KEYSTONE ELECTRONICS CORP.			
www.keyelco.com • NEW HYDE PARK, NY 11040 • Tel (516) 328-7500			
PART NAME		SNAP RIVET	
MATERIAL		NYLON UL 94V-2 (BLACK COLOR)	
FINISH		DRN BY	BOONE
NONE		APP'D	RH
TOLERANCES		DATE	9.29.06
DECIMAL	$\pm .010$ [ $\pm 0.25$ ]	SCALE	4X
ANGULAR	$\pm 1^\circ$	DWG NO.	
UNLESS OTHERWISE SPECIFIED		C	
		3441

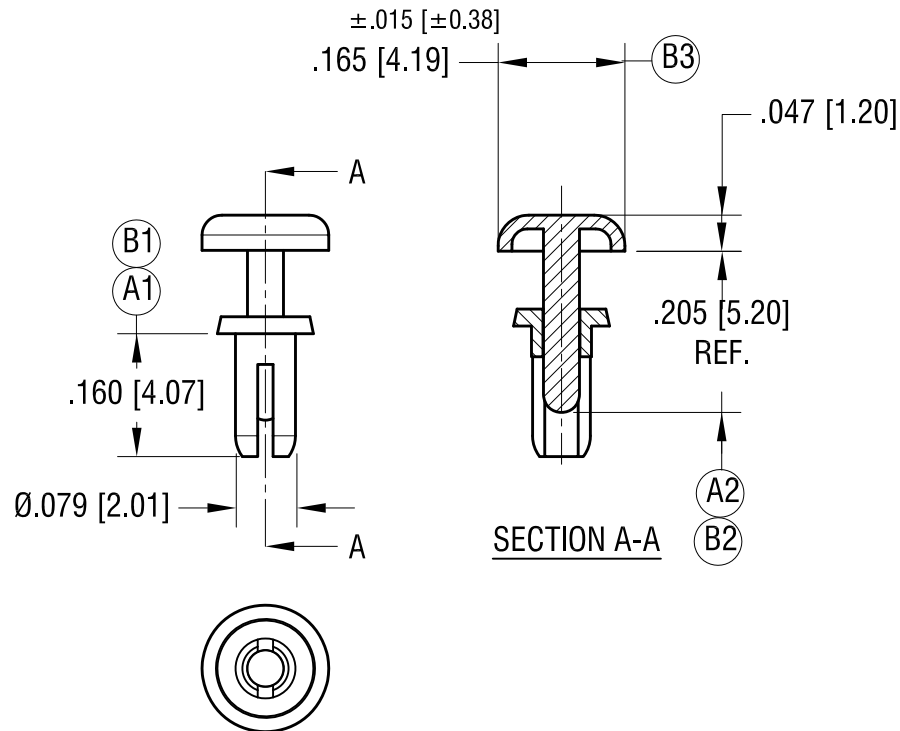
8.27.21	(B1) WAS .170, (B2) WAS .210 (B3) WAS $.165 \pm .010$ , ECN 21-098	B
7.15.21	(A1) WAS .160, (A2) WAS .220 CHANGE AS PER ECN 21-069	A
DATE	DESCRIPTION	REV.
